Subject: MHI's Revised Response to US-APWR DCD RAI No. 427-2909 REVISION 1 (SRP 12.02)

Revised Response to Request for Additional Information
No. 427-2909 REVISION 1

US-APWR Design Certification

QUESTION NO.: 12.02-19

Figure 1 Treatment of the Cubicle in the Airborne Activity Calculation (example)

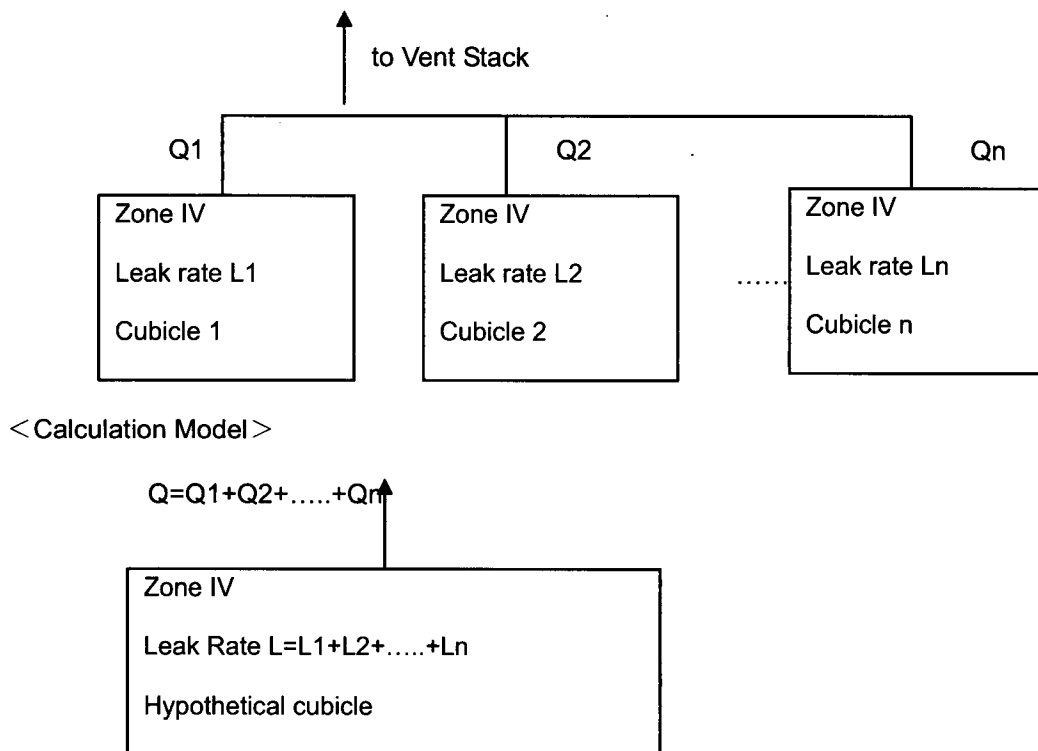
- I) A number of "Radiation Zones" are listed (III to VI). Since there are other zones depicted in Figures 12.1-1 sheets 1-34 "Radiation Zones for Normal Operation/Shutdown", and the RB and AB have piping and equipment areas containing these missing zones, it is not clear how the listed zones were derived and where they are defined.

As depicted in Figure 1 below, this calculation models all cubicles assigned to the same radiation zone category as a single hypothetical cubicle. Airborne activity is calculated using Eq. 3 (see the answer to 1a above) and does not depend on cubicle volume. Therefore, this

treatment considers all of the cubicles in the radiological controlled area (RCA). Radiation Zone I is not RCA. Radiation Zone II is the RCA, but the equipment that can potentially leak radioactive liquid is not located in this Zone. The equipment that could potentially leak radioactive liquid (e.g. pumps) is installed in Zones III and higher. Therefore, MHI revised DCD Table 12.2-60 and Table 12.2-61 with a note.

Figure A-2: Comparison between US-APWR estimation conditions and realistic conditions

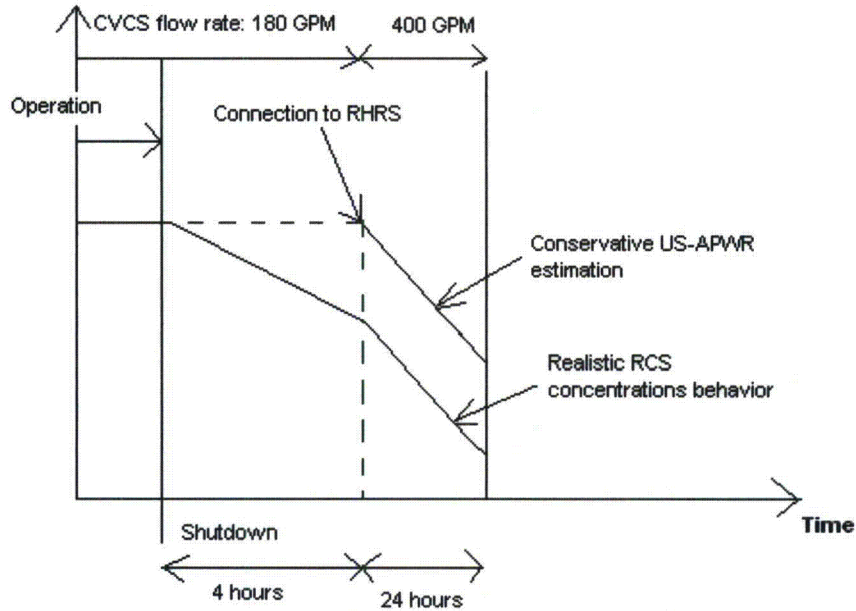
3. The values in Table 12.2-72 do not appear to be consistent with the values in Table 12.2-52 "RHR System Activity – 4 Hours After Shutdown", even when the Table 12.2-52 values are corrected for clean up to the EPRI Primary Water Chemistry Guidelines, and then diluted with distilled water (not RWSAT) to fill the Cavity.

Figure A-2 describes the assumptions used in the estimation of RCS concentrations for the US-APWR in comparison to the actual conditions expected.

As shown in Figure A-2, the US-APWR estimation conservatively assumes that the concentration of radionuclides in the RCS remains constant during the period between the beginning of shutdown and the start of the RHRS (i.e., no decay and no CVCS purification is credited prior to RHRS initiation). Both decay and purification (400 gpm) are credited for a 24 hour period between the connection of the RCS to the RHRS and the end of shutdown when operators can begin refueling operations. However, practical considerations of refueling outage risk management will prevent fuel movement until well after 24 hours, resulting in additional purification and decay beyond what is currently conservatively modeled in the US-APWR airborne activity concentration evaluation.
